To Company:	Ironstone Developments Pty Ltd	Email:	tim@woodburycivil.com.au
Attention:	Tim Mullaney	Date:	19/5/2023
From:	Neil Pennington	Ref:	181724-RF11
Copies to:	Jonathan Berry (Wedgetail)	Pages:	4

Subject: Response to RFI – Deep Creek Quarry (SSD-11591659), Limeburners Creek NSW

This letter report provides responses to issues raised in a Request for Further Information (RFI) from the Department of Planning and Environment (DPE) dated 21 March 2023 following their review of our noise and vibration assessment for the proposal. The additional information request is reproduced below.

Fig 1. Noise Sources for Stage 1, Scenario 2.

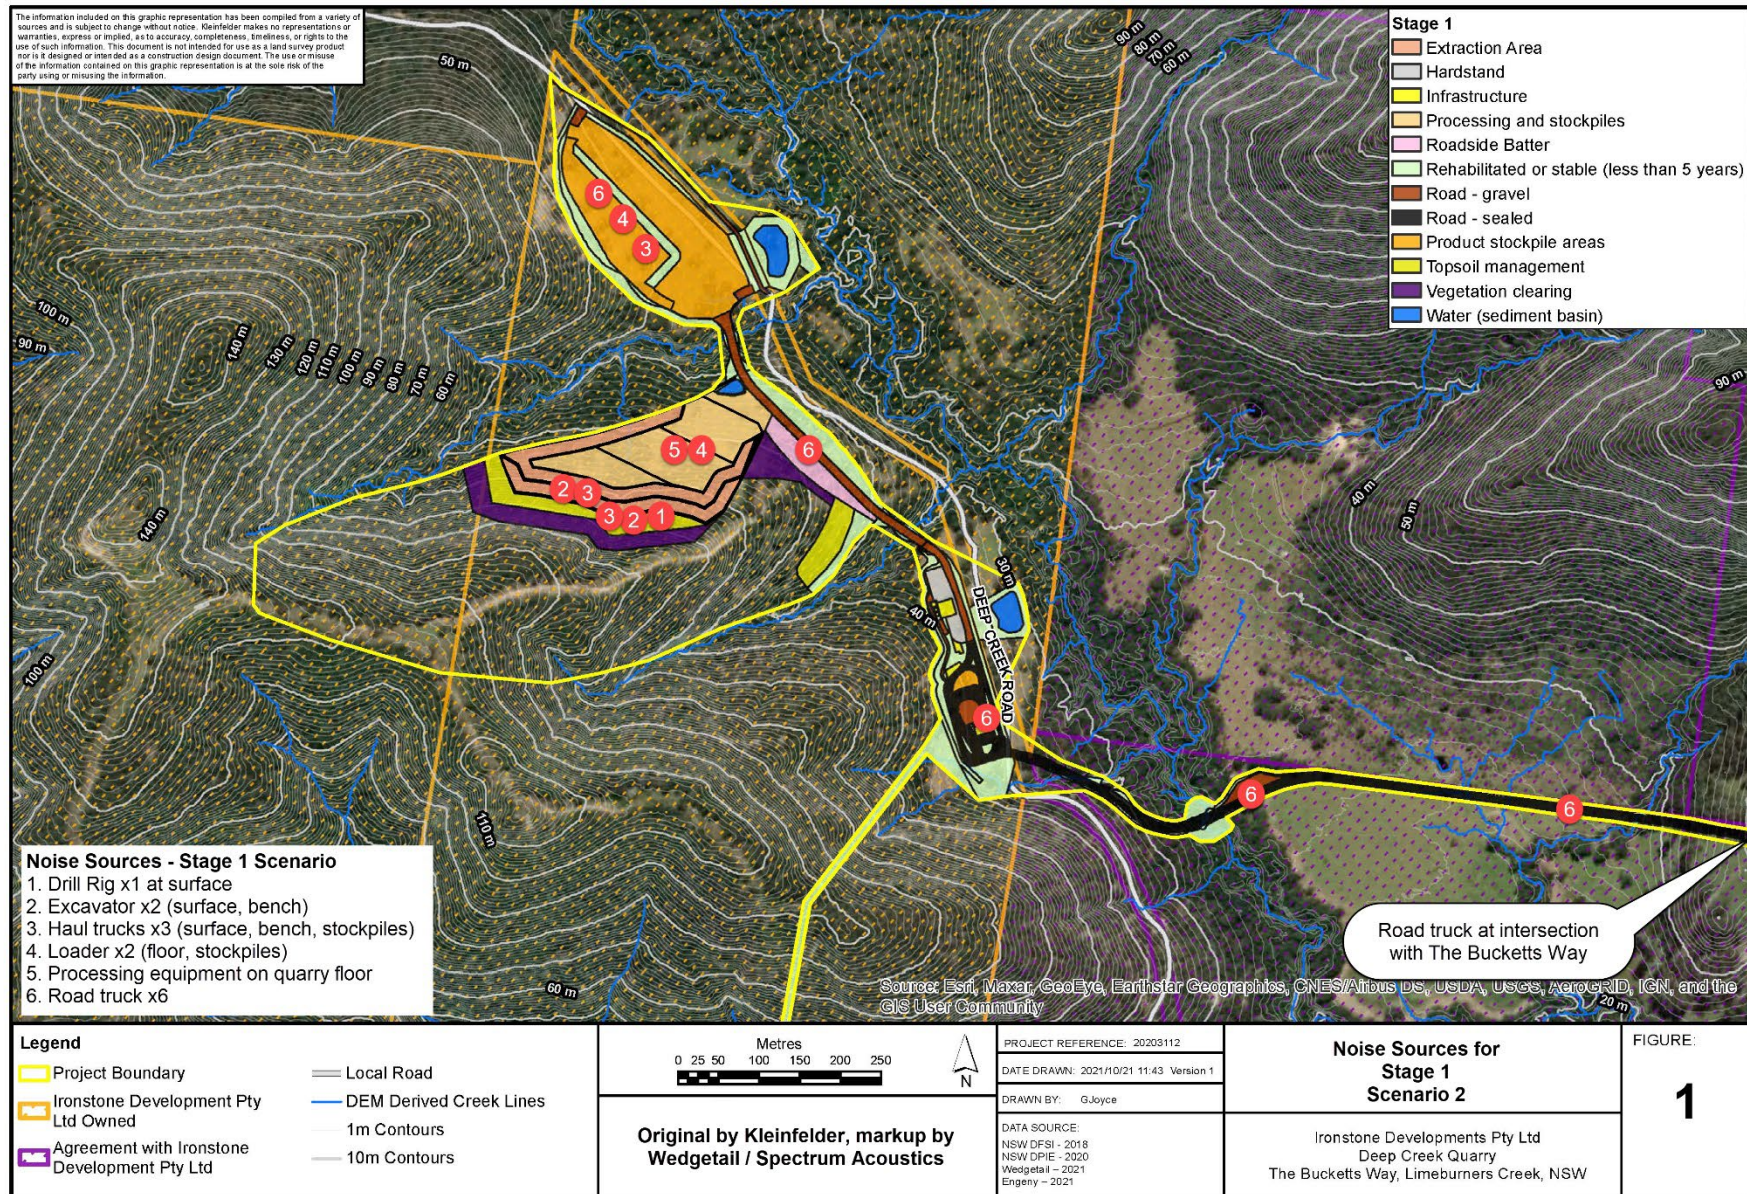
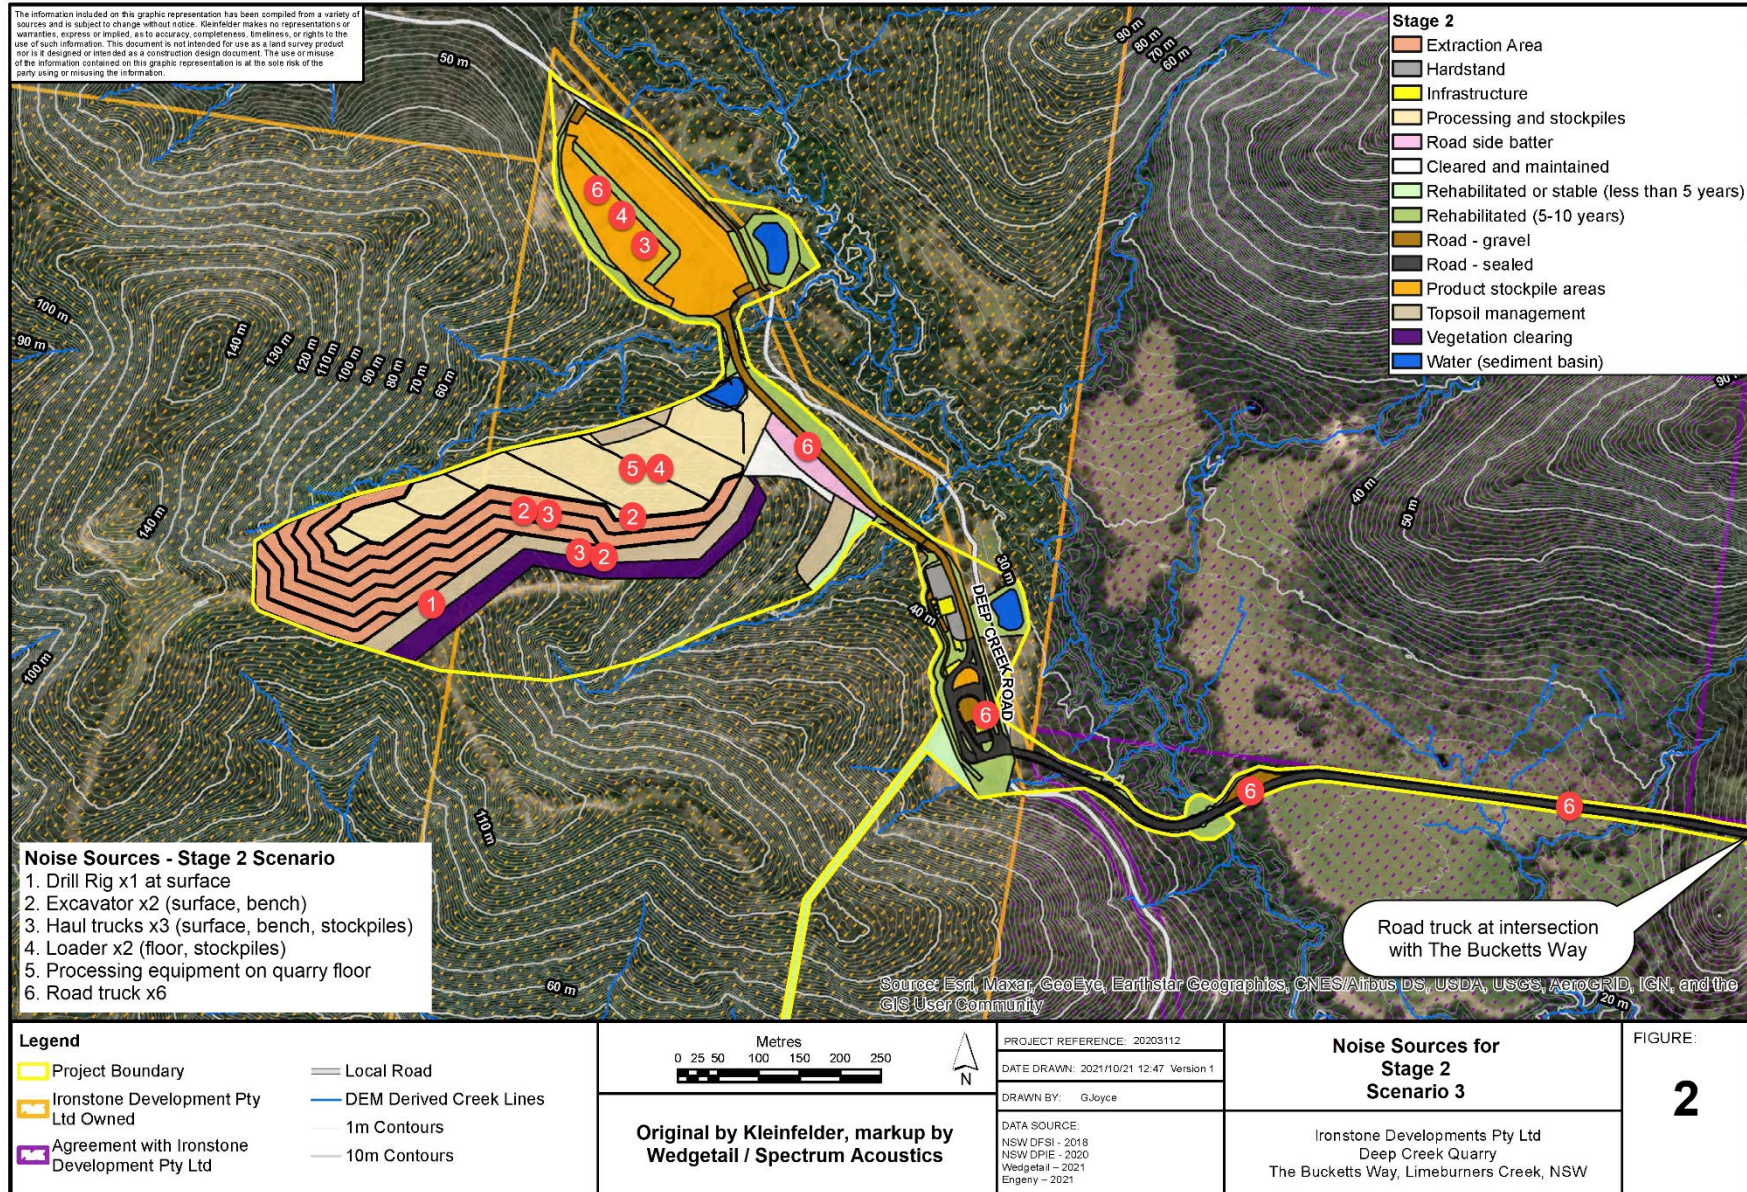
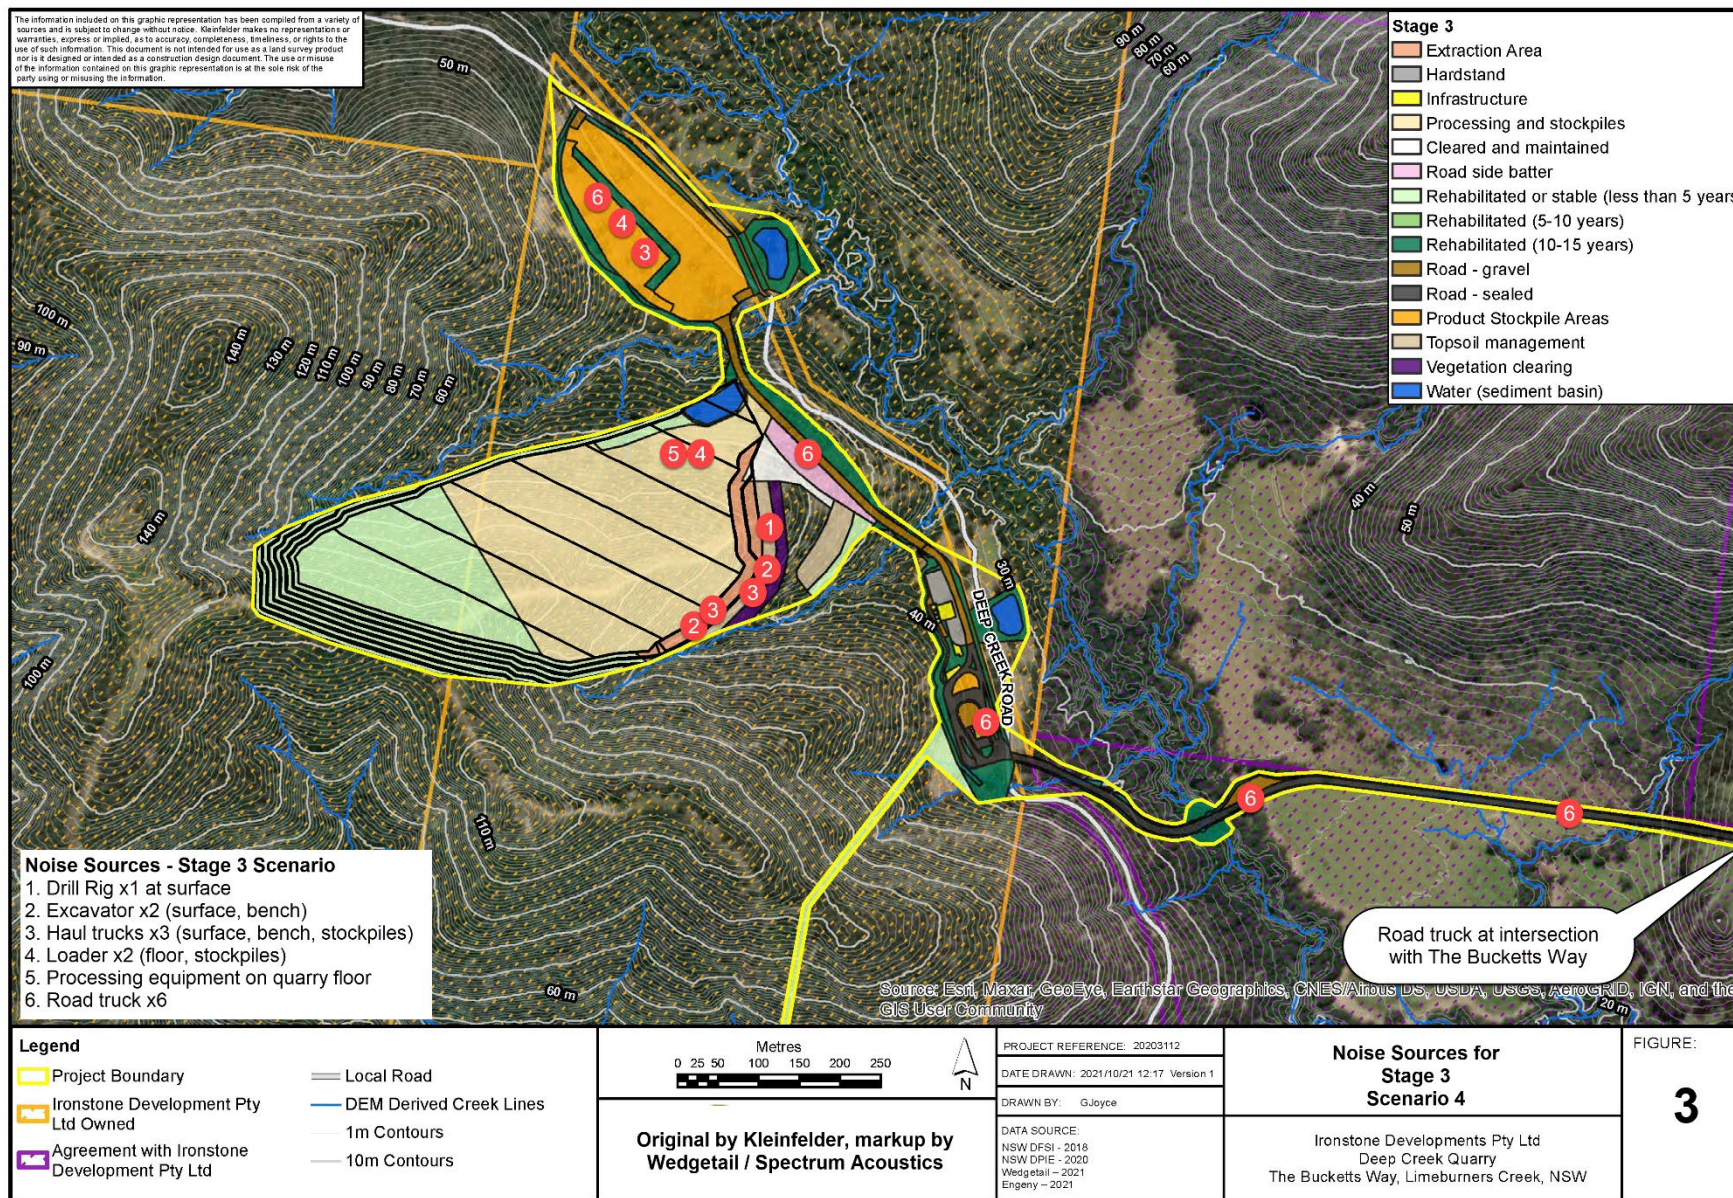
- Further evidence to demonstrate that a reasonable worst case scenario has been included in the noise modelling predictions. The department notes that the modelling scenarios described in the NIA do not include equipment operating at elevations above the pit floor (excepting the drill rig), or at locations in the south-western side of the extraction area. The department is also unable to confirm if the dozer (listed in Table 7 of the NIA) has been used in the noise model. The department also notes that only three of the four operational project stages have been included in noise model predictions. If necessary, revised noise model predictions should be provided to account for a reasonable worst case scenario, with consideration of these comments.

However, to clarify, three revised worst case scenarios for noise modelling have been identified and are shown in the figures below, with an excavator, drill and truck on the top bench. These figures are updates of Figures 3-6 in our original acoustic report with the relocated excavator and dumper added for revised noise modelling only increasing the combined surface level sound power level by 1-3 dB.
